Cree® CLM2B Product Change Notification

PCN Reference Number: CREE-PCN-0871

Date Issued: August 12, 2019

The height dimension tolerance change is shown below:

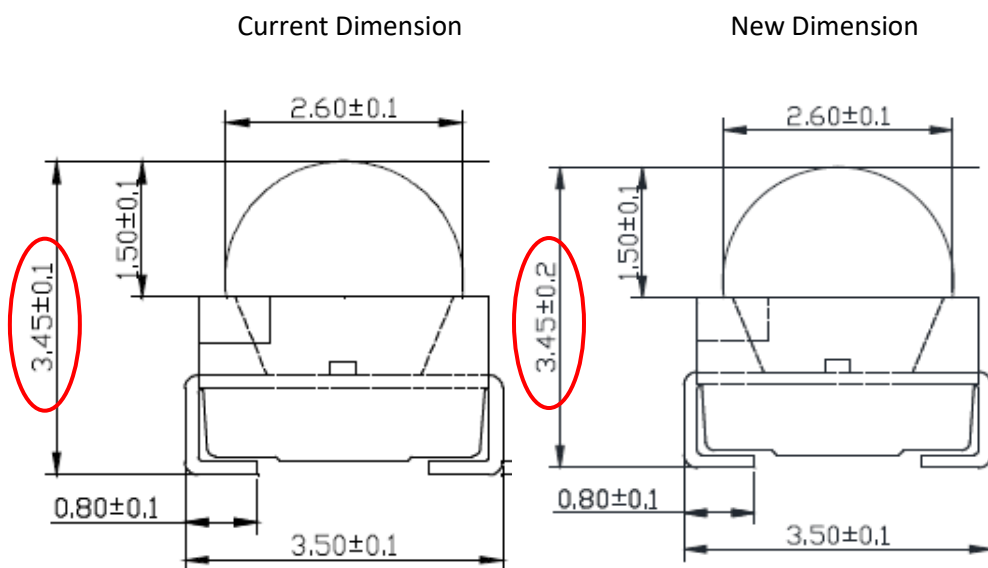
The height tolerance of CLM2B red and amber LEDs is being changed from ± 0.1 mm to ± 0.2 mm on the data sheet. There is no change to how the parts are made. The height of the parts can be from 3.25 to 3.65 mm. Please refer to the latest data sheet on www.cree.com.
